Re: Response to Engineering Review Letter dated November 4, 2014
TurboCAM - Map 234 / Lot 1.5
Barrington, NH

This letter is provided in response to the engineering review letter provided by DuBois & King, Inc., dated November 4, 2014. Please find enclosed the following:

REVIEW COMMENTS

GRADING, DRAINAGE, UTILITIES & EROSION CONTROL PLAN

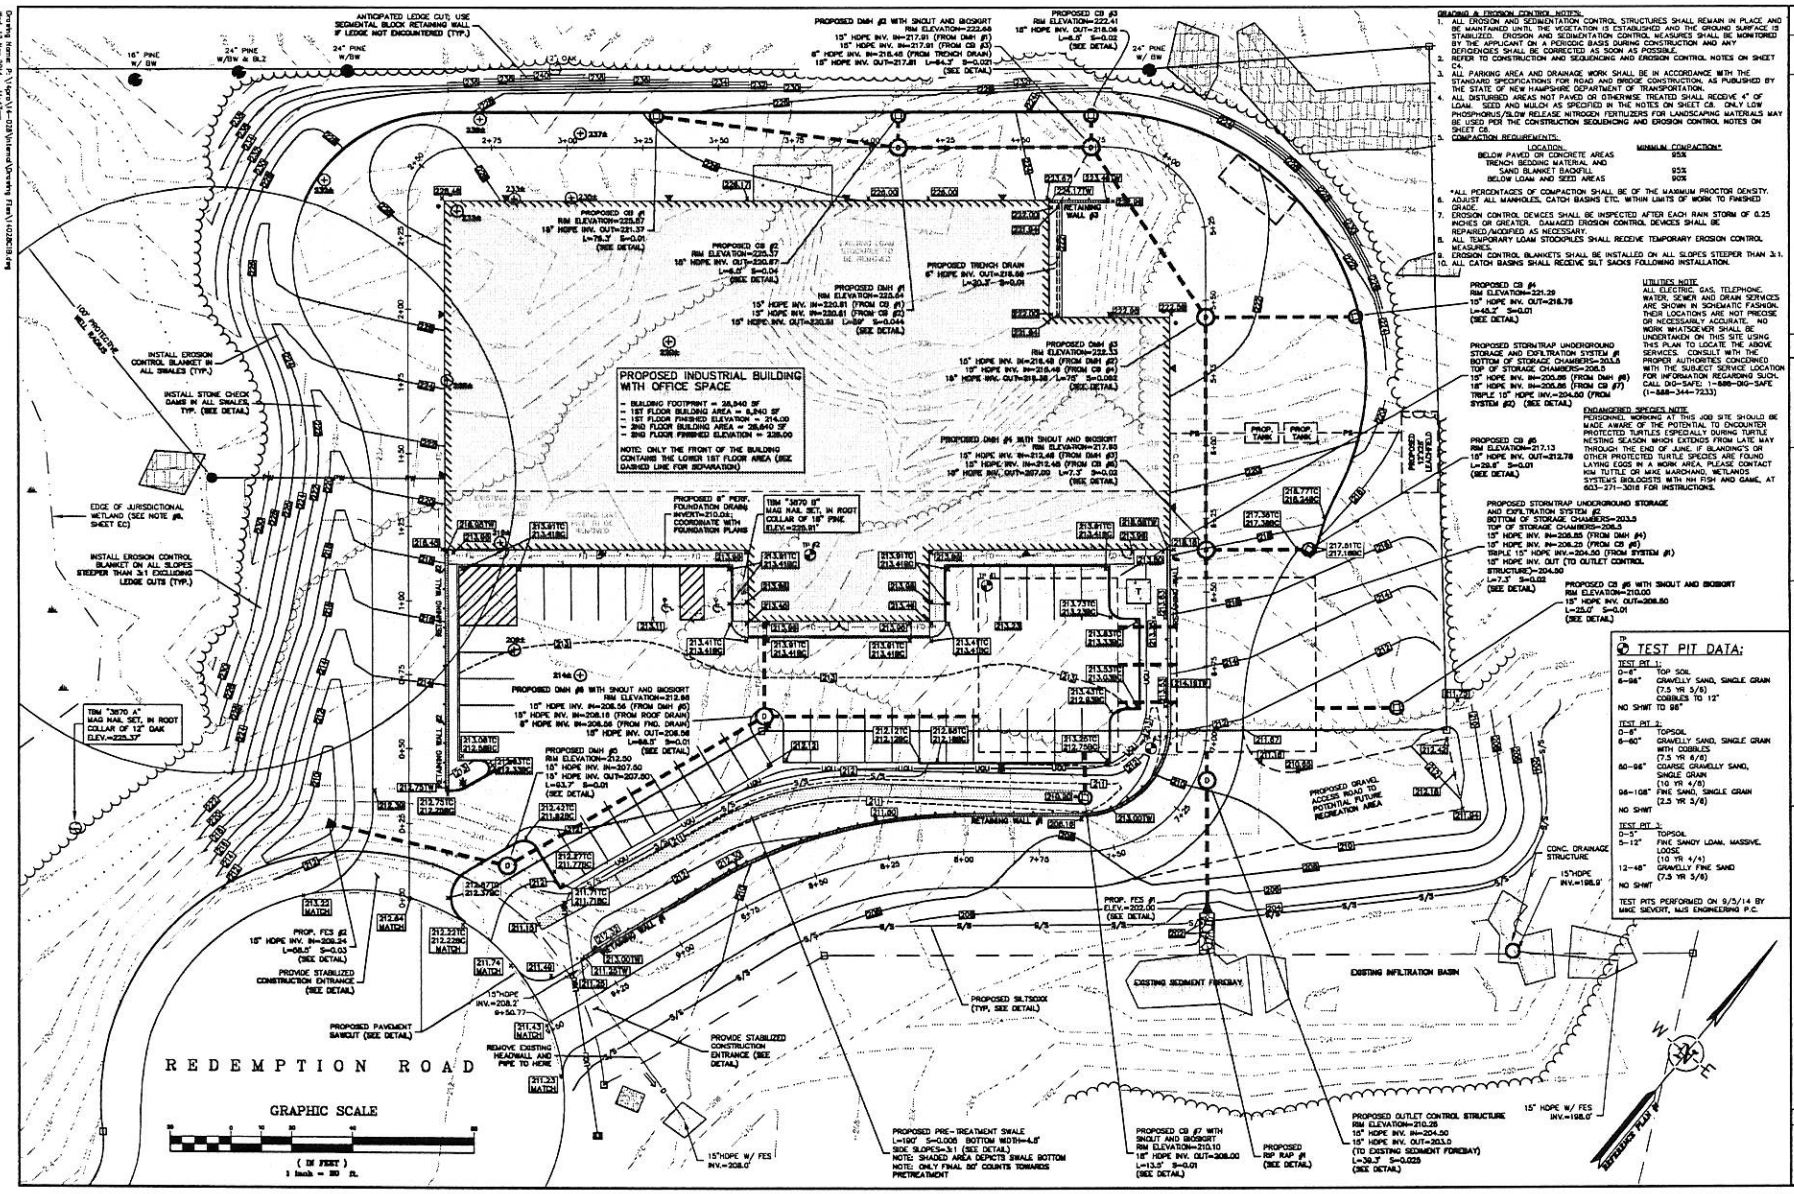
1. *Although Sheet C2 - Grading, Drainage, Utilities & Erosion Control Plan identifies isolated temporary erosion protection measures (i.e. construction entrance, stone check dams, erosion control blanket) during construction activities in accordance with Article 3.5.3 of the Site Plan Regulations, the plan does not include limits of silt fence within disturbed areas.*

2. *The plan set does not include a temporary erosion protection measure construction entrance, or silt fence detail in accordance with Article 3.5.3 of the Site Plan Regulations.*

8. *The pre-treatment measure Snout and Bioskirt appears to be only shown at DMH No. 2. We recommend that this pre-treatment measure be at all drainage structures (i.e. DMH No. 4, No. 6 and CB No. 7) immediately prior to discharging collected stormwater to the StormTrap system.*

Siltsoxx locations have been added to Sheet C2. A Siltsoxx Detail had been and will continue to be shown on Sheet C7. We trust that Siltsoxx can be used as an acceptable alternative to silt fence.

Sheet C2 provides notes with leaders pointing to the entrances to the proposed development requiring stabilized construction entrances. The Stabilized Construction Entrance Detail on Sheet C10 provides construction requirements.

Snouts and Bioskirts have been added to all drainage structures which discharge directly into the StormTrap system. This includes DMH #4, DMH #6, CB #6, and CB #7. Sheets C2 and C9 have been revised accordingly.

4. *The Drainage Report does not overlay the watershed boundary on a USGS quadrangle map. We were unable to confirm the watershed delineation.*

Refer to the enclosed map.
